6/17/2026 | 6:00 PM

**Municipal Services Center, Council Chamber
3600 Tremont Road**

- a. 4684 Riverside Drive (VAR-25-26) - To allow the construction of a 1,300-square foot detached garage that is 20 feet tall, in lieu of the 17-foot maximum height, and exceeds the maximum 870-square foot size. [A smaller version was previously approved by BZAP via VAR-35-20 on January 6, 2021.]
- b. 2826 Zollinger Road (VAR-27-26) - To permit a modern renovation design that does not meet Residential Design Standards, and includes a garage addition that encroaches up to 3.54 feet into the 10-foot minimum side yard setback.

Proposed Elevations

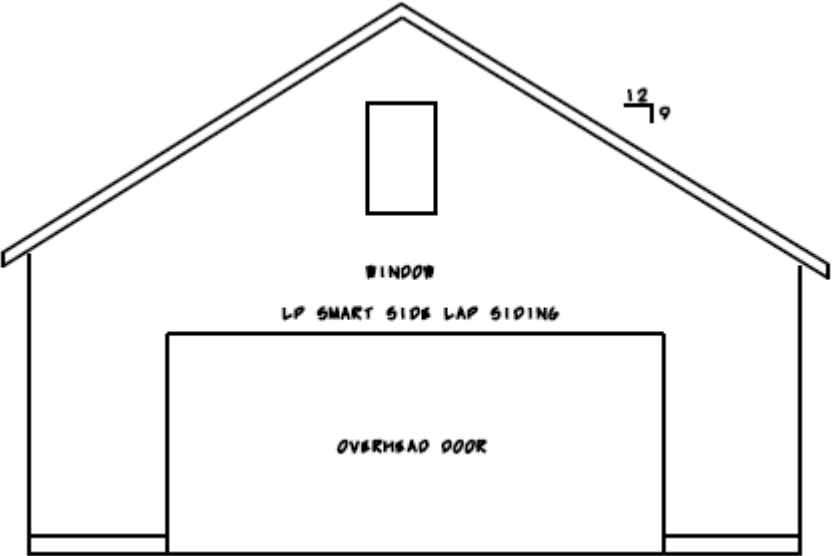
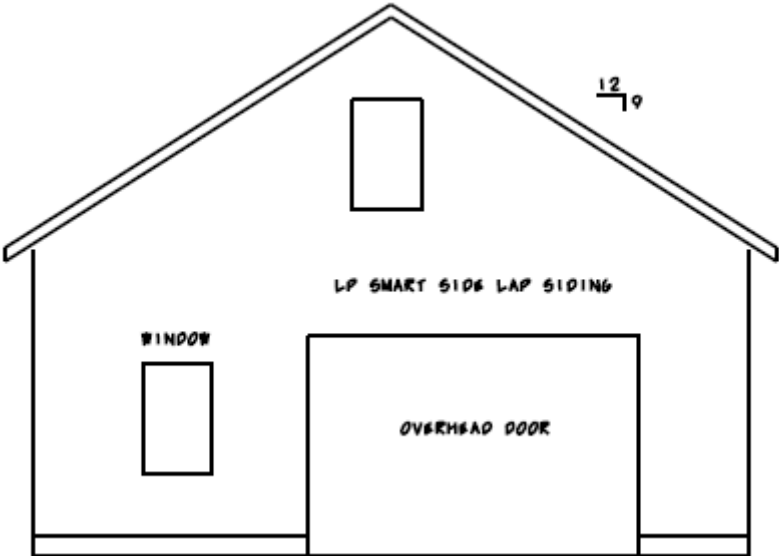
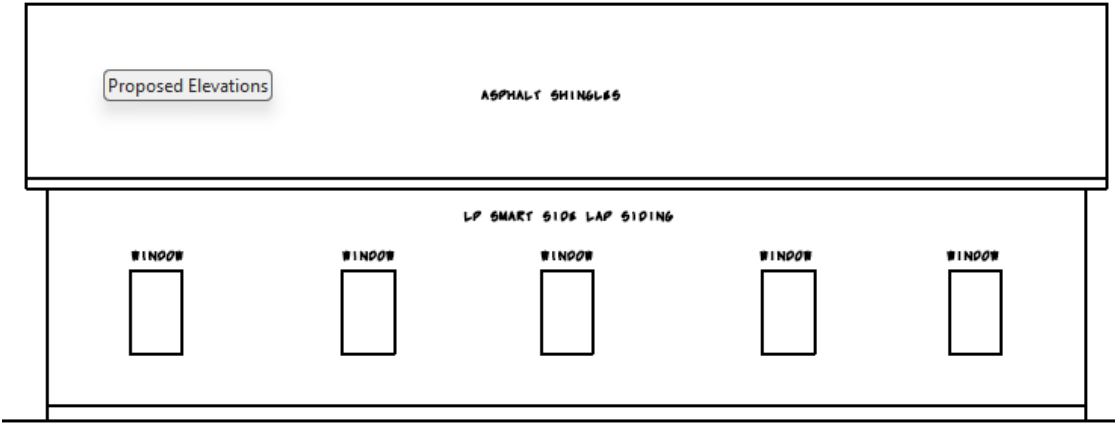
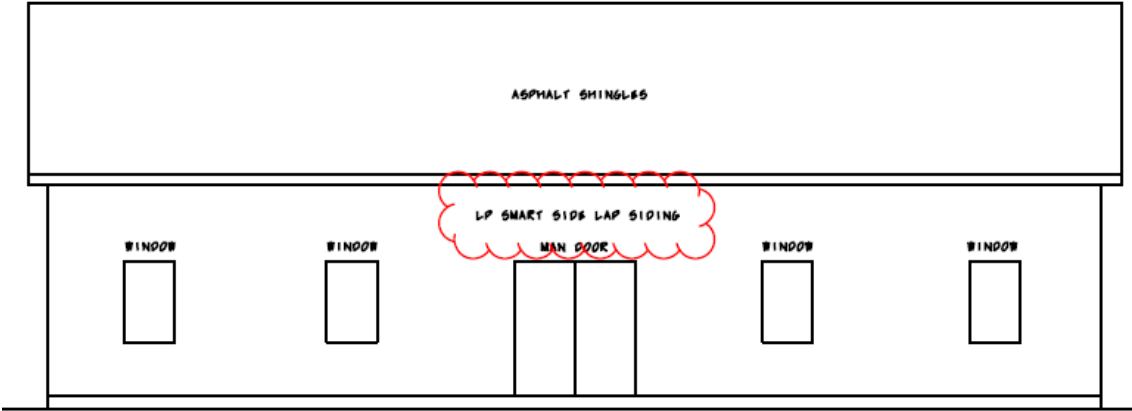
line. The proposed structure measures 26 feet in width, 50 feet in depth, and 20 feet in height [exceeds the 17-foot maximum from grade]. Its plate height is nine feet above the parking floor per code. The garage design includes a gable roof at a 9/12 pitch and LP Smartside lap siding siding to match the house. The first floor includes vehicle and boat parking and storage, while the second floor includes office space — a note has been added to prohibit sleeping-quarters. Architectural features include overhead garage doors on both the front and rear elevations, a man door on the north elevation, and a total of 12 windows distributed across all four elevations. Building, development, and front yard development coverages all comply with City standards.

Staff has reviewed the application and plans, discussed it with the applicant, and visited the site. The proposed detached garage/pole barn is massive and would be one of the biggest in the city. Shifting the proposed garage location two feet further from the side property line or reducing the garage width by two feet would completely eliminate the need for variances. Staff believes that this is an obvious solution which should be fully considered.

20' tall with 9' plate

Conversely, the proposed design is better than the one previously approved by the Board in 2021, and the plate height has recently been reduced to a compliant level. It is also further from the shared property line than the previous plan. The proposed exterior materials match the existing house, and access to the new structure would be provided by extending the existing driveway. The structure would be located away from underground infrastructure and will not be readily visible from Riverside Drive. Should the Board entertain a motion on this variance application, Staff would recommend consideration for Findings #4 (character of the

Previously Approved Variance

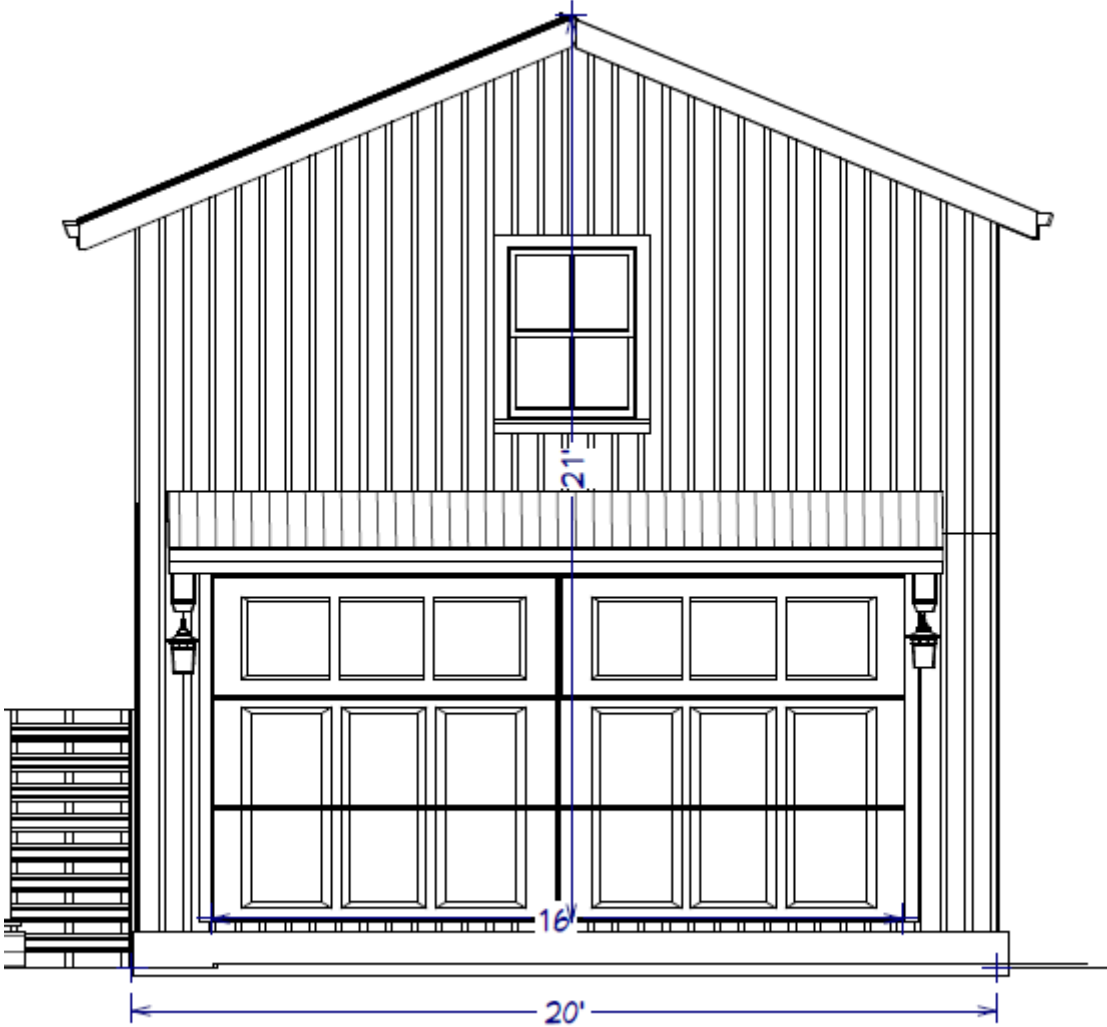
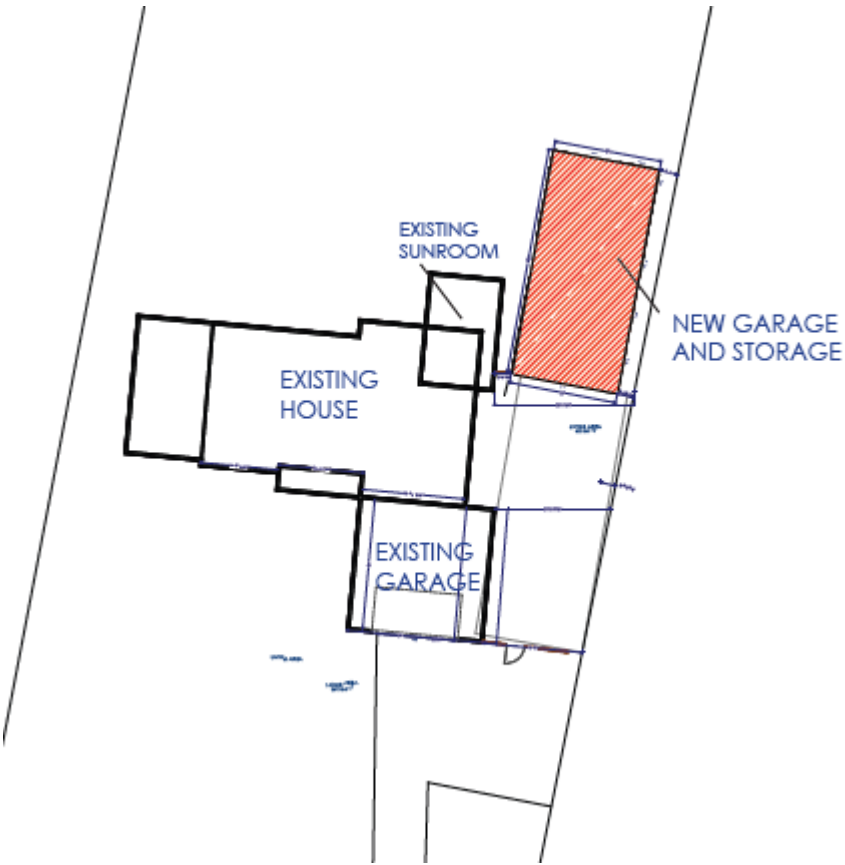
Although the proposed garage is 460 square feet larger than the plan previously approved by the Board, the revised design represents an architectural improvement and is located seven feet further from the south property line than originally approved.

19'-6" tall

NORTH ELEVATION
SCALE: 1/4"=1'-0"

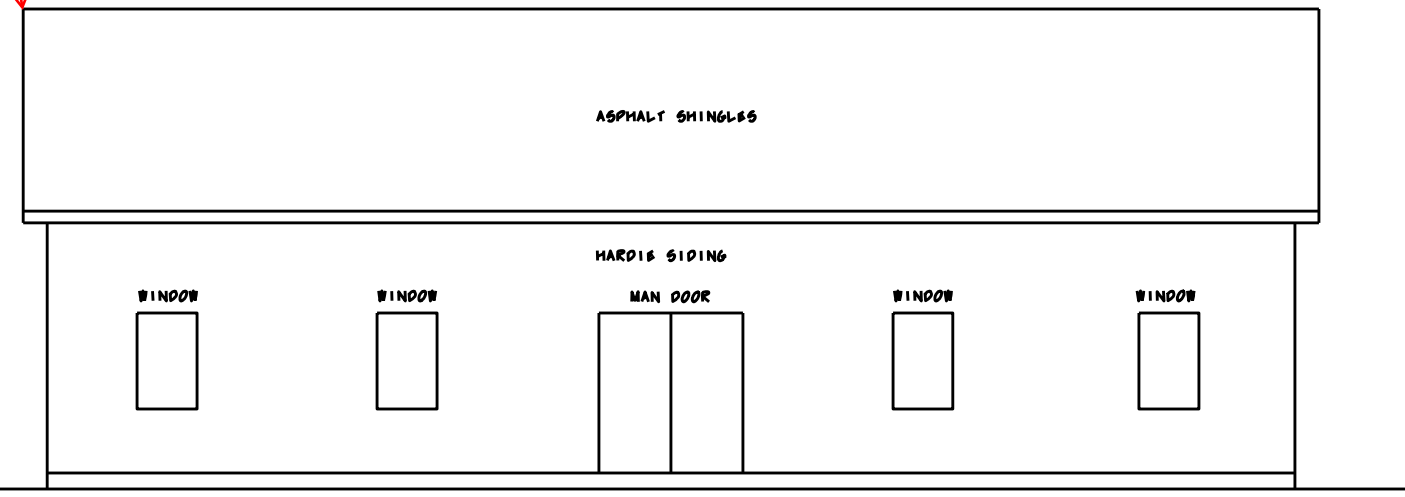
20' tall, in lieu of 17'
maximum height

SECTION - NEW GARAGE
21' HEIGHT OPTION

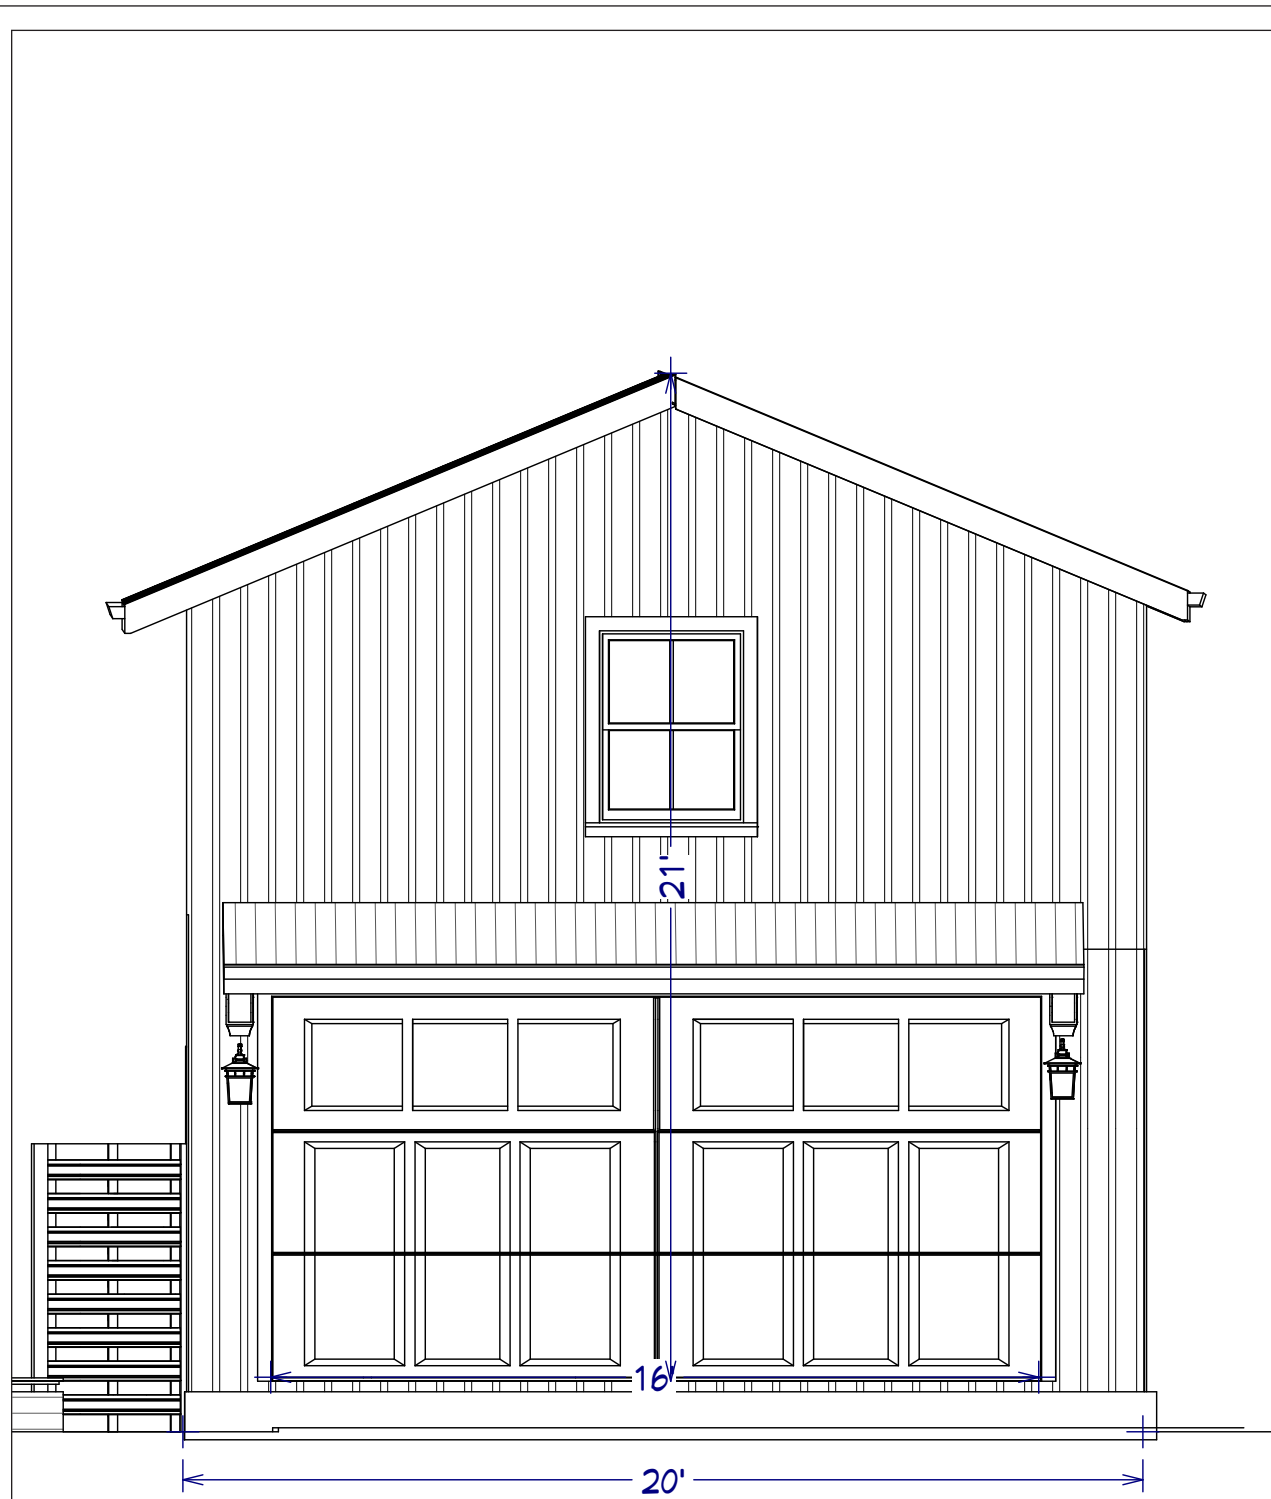
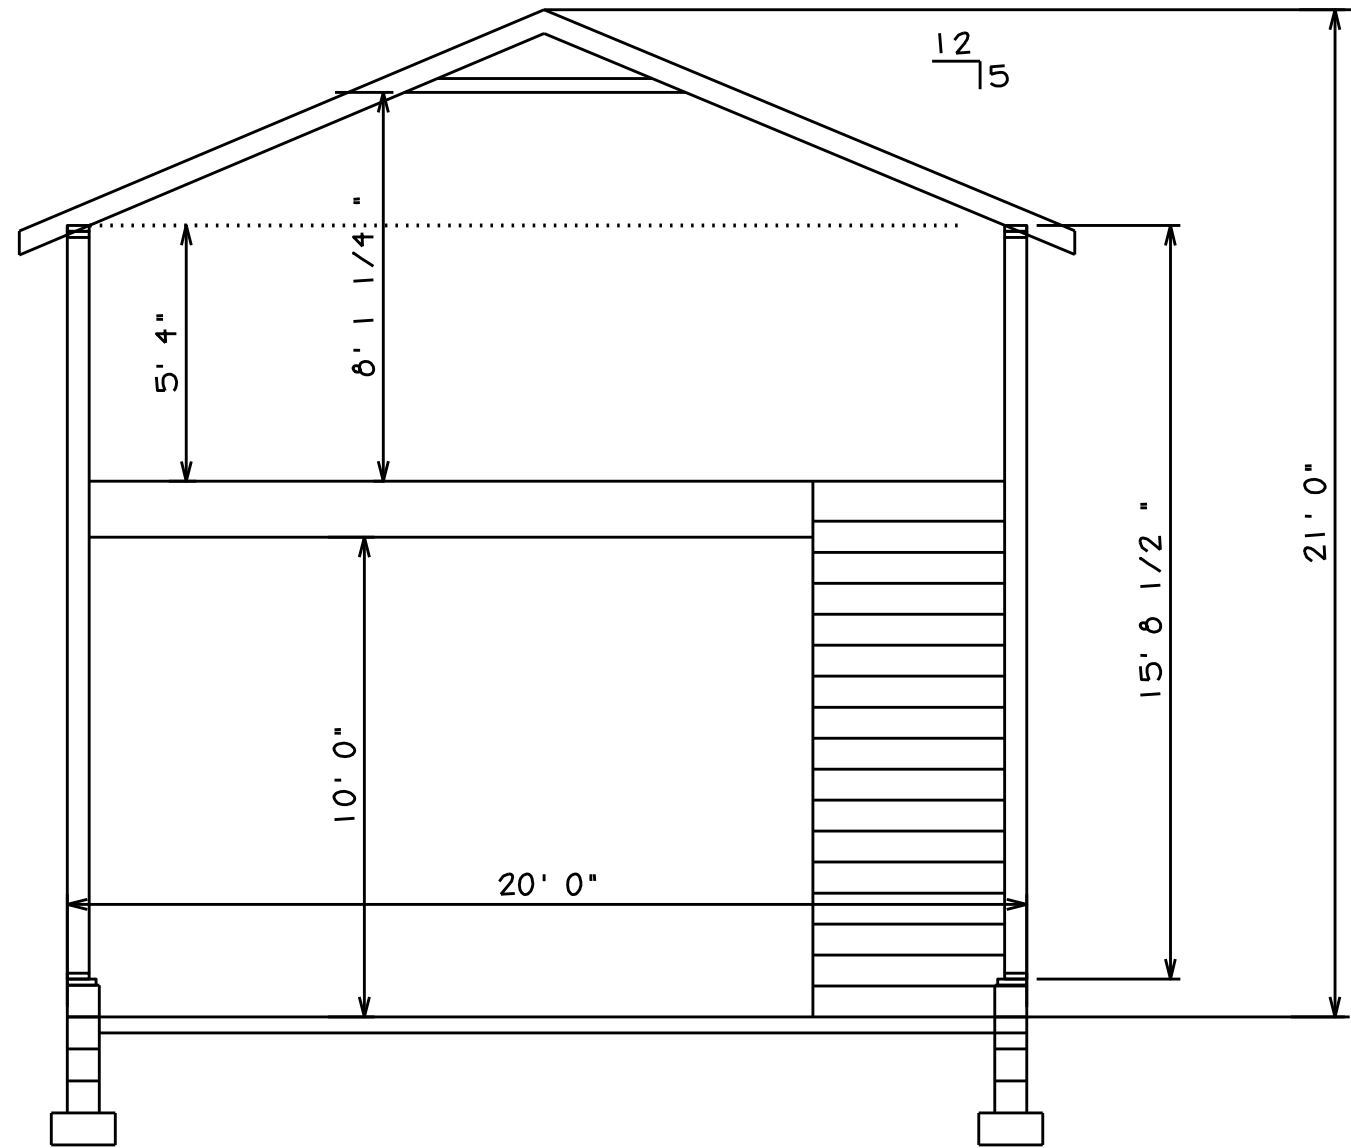
Discussion: Mr. Milam gave an overview of the request. The original submittal included a detached garage that was almost 23 feet in height. The updated plans show the garage at 21 feet in height and the roof pitch was adjusted to match the home. The head height on the second floor decreased by five inches. He reminded the Board that they were comfortable with the location, but had concerns about the height and design

Mr. Milam, in response to a question from Mr. Tullett, remarked that reducing the garage to 19.5 feet would be closer to code requirements, which is 17 feet. The plate height would remain an issue as it is well above code.
